Environmental Impact Analysis Process

FINAL
ENVIRONMENTAL IMPACT STATEMENT

MX: MILESTONE II

- LETTERS RECEIVED FROM AGENCIES AND ORGANIZATIONS
- RESPONSES TO QUESTIONS RAISED BY THE PUBLIC
- PUBLIC HEARING TRANSCRIPTS

Figure 1-11. South Platte Plains Basing Area Comparison Area.

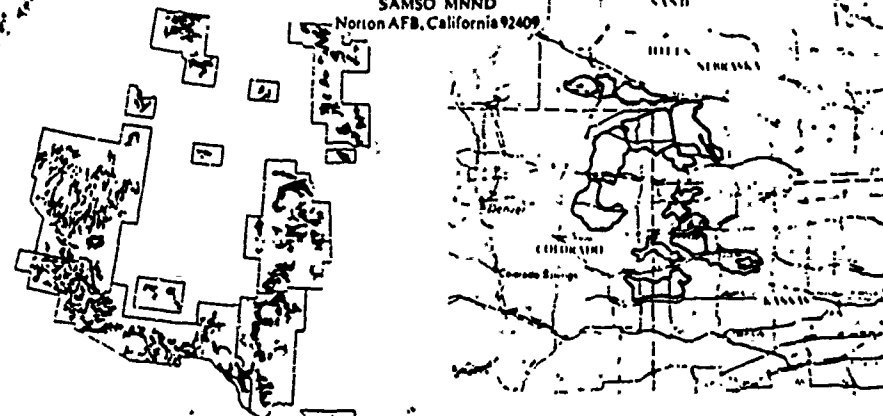
Following is a list of towns compiled from looking at a road map and comparing it to Figure 1-11. (IV-62) All are generally in the area under consideration for the MX. We would like to know more exactly 1) which towns are inside the BMCA; 2) which towns are inside the BMCA but not listed here; and 3) which ones are outside.

Is the map from Draft Environment Impact Statement
MX Milestone 11, Figure 1-11 going to cover this
area, or could it be even more? I need to know
more, as I'm in the area mentioned. How soon
would this project begin also? Will this require
the farmers to move off the land and etc?
